**WHEELING PLAN COMMISSION
THURSDAY, FEBRUARY 28, 2019 6:30 P.M.**

**AGENDA FOR A REGULAR MEETING OF THE PLAN COMMISSION
Board Room - 2 Community Boulevard, Wheeling, Illinois**

RE: **Docket No. SCBA 19-3**
City Works Eatery and Pour House
365 W. Dundee Road
Appearance Approval of Wall Sign

RE: **Docket No. SCBA 19-4**
Fifth Third Bank
125 McHenry Road
Appearance Approval of Wall and Freestanding Signs

HOUSE OF RENTAL
 318 NO. MILWAUKEE
 WHEELING ILLINOIS

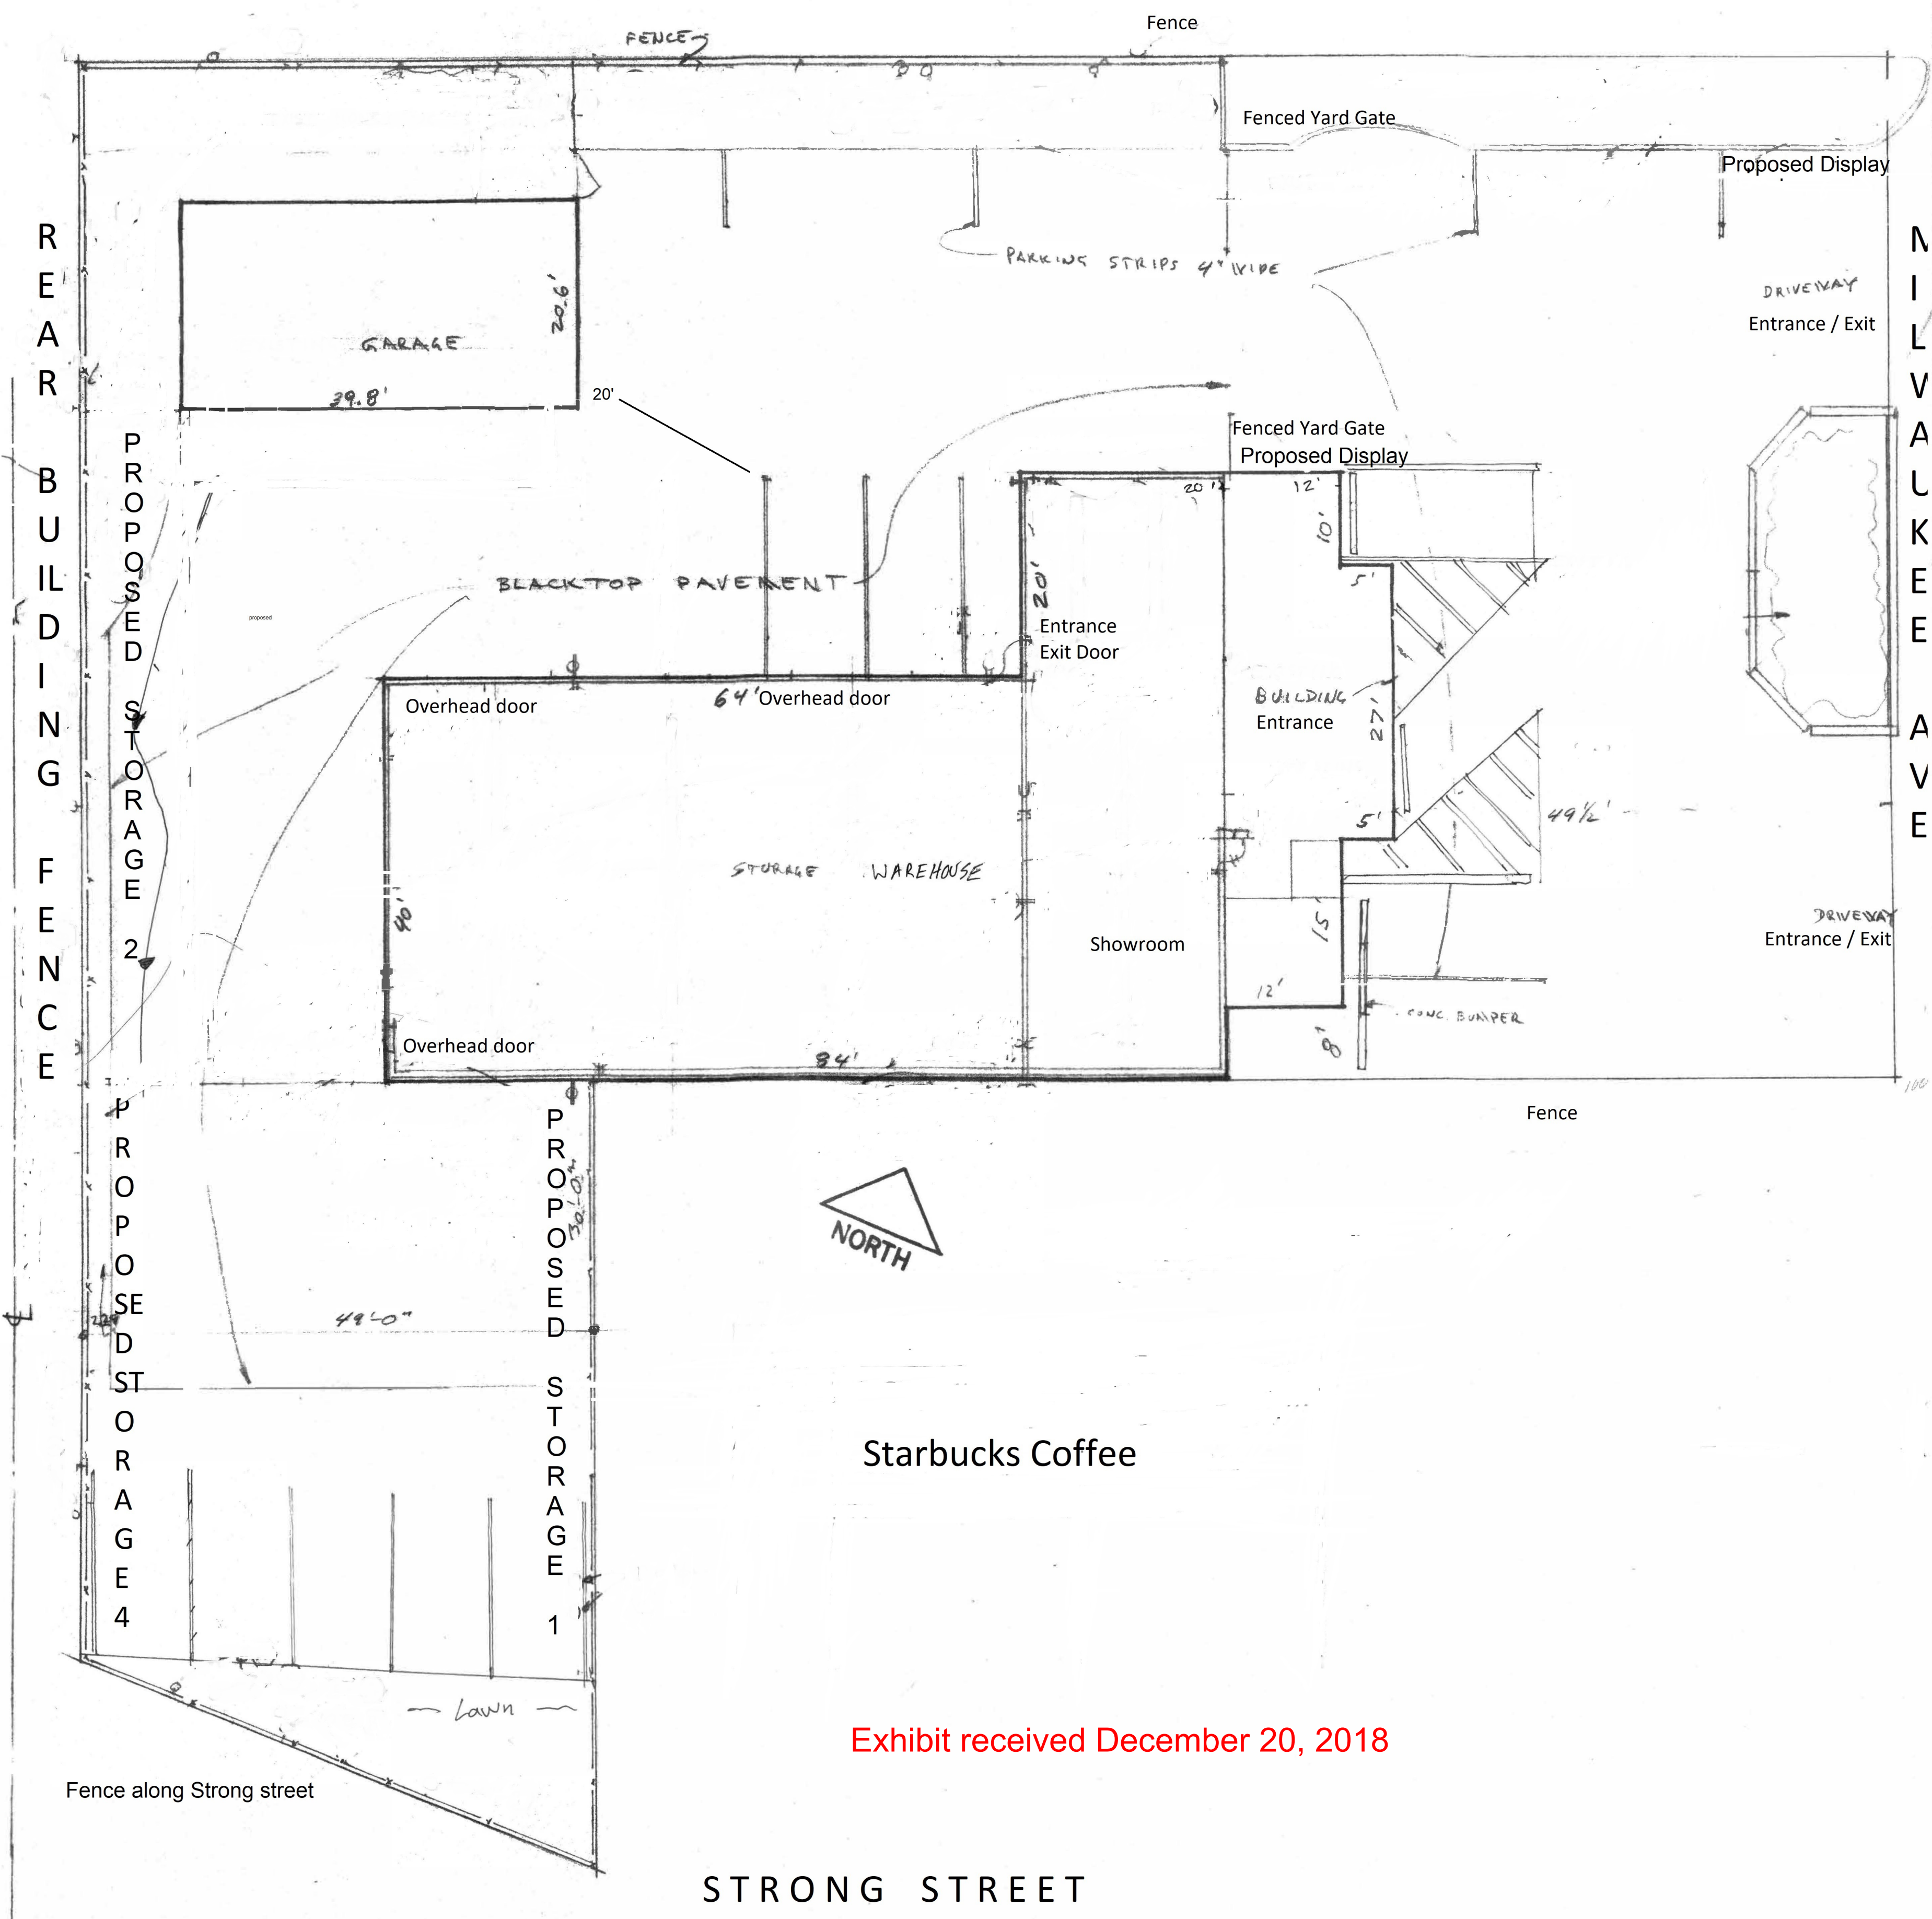
Customer parking is provided in the front lot. The existing striping includes a total of seven parking stalls. However, the site plan indicates a total of six because only one angled parking stall is shown. The Plan Commission may wish to confirm if the front parking lot is to be restriped per the site, which reduces customer parking by one stall (to six).

All outdoor storage areas are located in within the fenced area. The petitioner proposes to remove the western parking stall in the parking row just north of the building to provide emergency clearance as requested by the Fire Department. It does not appear that storage along the property lines would impact access. This amended site plan was presented at the December 20th Plan Commission meeting, and the Fire Department confirmed the adjustment allowed for better emergency access.

Landscaping: A landscape plan is provided that notes existing trees around the perimeter of the site, some of which have been removed. The petitioner plans to install three juniper shrubs in the existing bare planter space at the front of the parking lot.

Fire Department Review: The Fire Department’s previous review from November 21, 2018 noted the concern that the outdoor storage will impact emergency access. The revised site plan, received December 20, 2018, has resolved the Fire Department’s comment.

NORTH ELEVATION SCALE: 3/32" = 1' - 0"

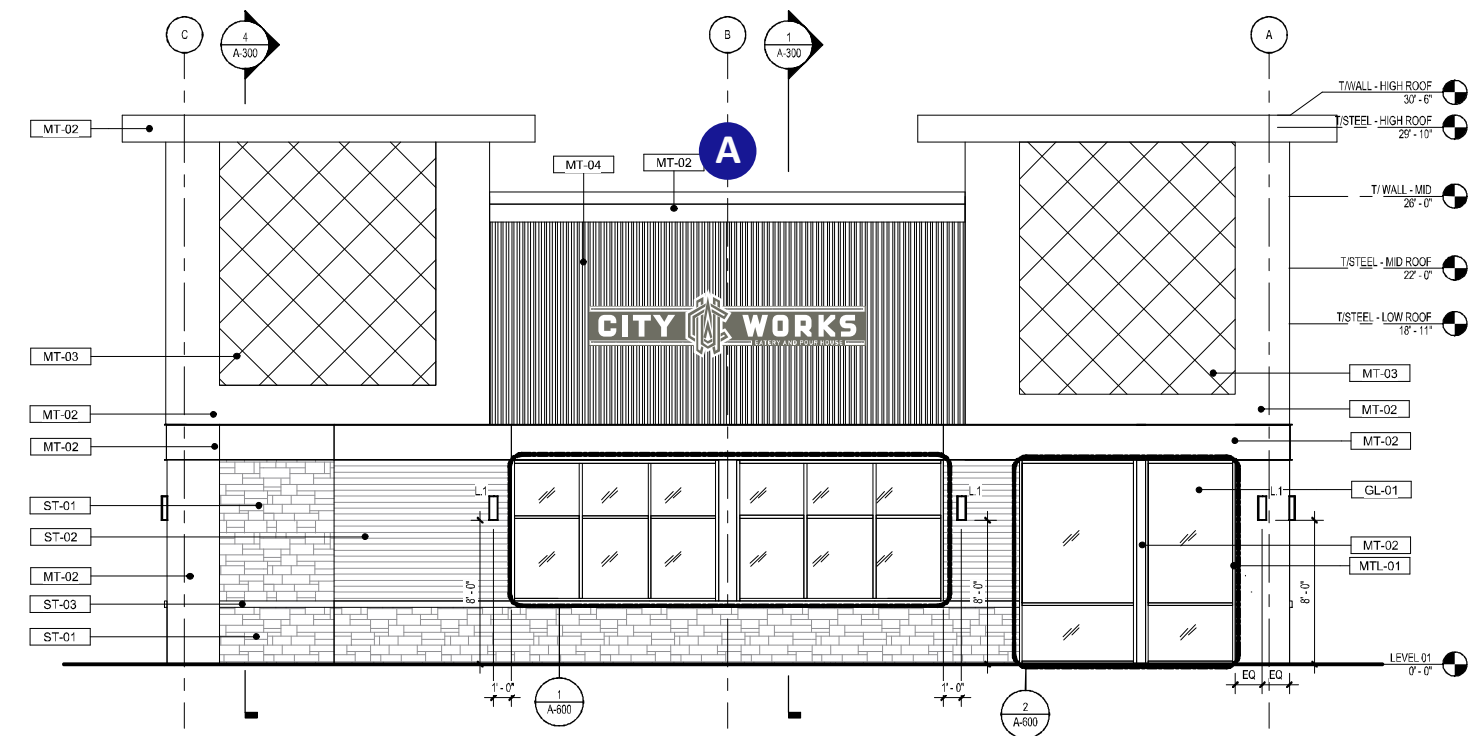
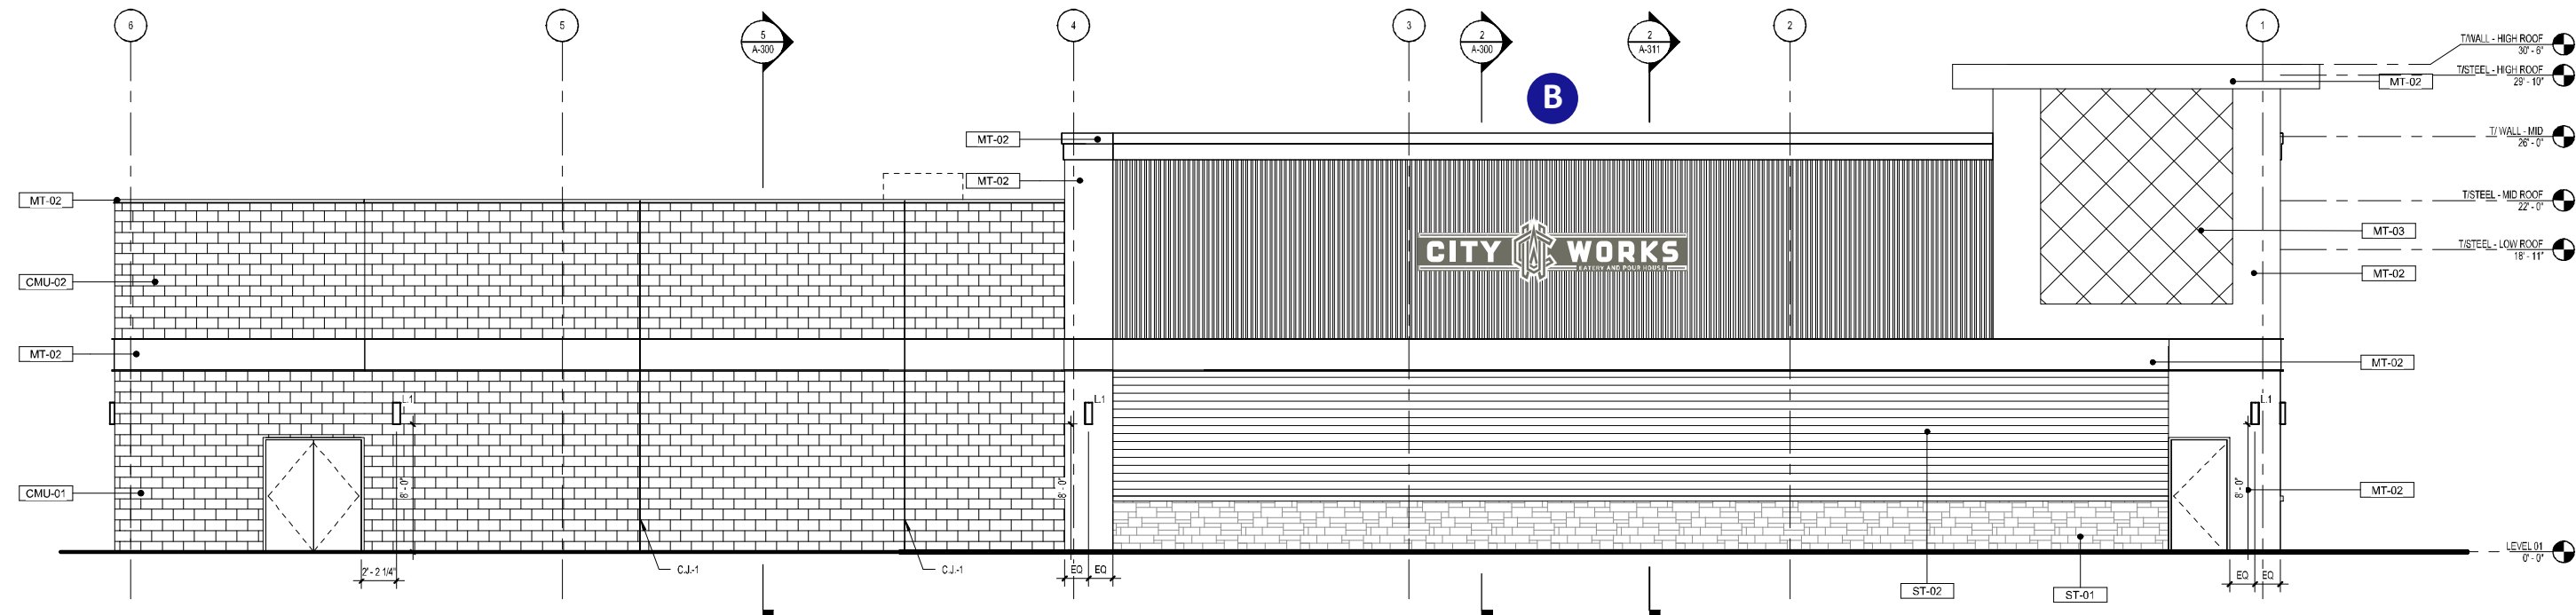
The limitations on the allowable sign area for additional wall signs does not take into consideration the unique layout of the Wheeling Town Center. The current regulations of the Sign Code are more applicable to a traditional in-line (strip style) shopping center. The Wheeling Town Center has multiple free-standing buildings that are uniquely laid out. Additionally, the multiple points of entry to the site and multiple parking lots creates added need for signage beyond what was anticipated by the Code.
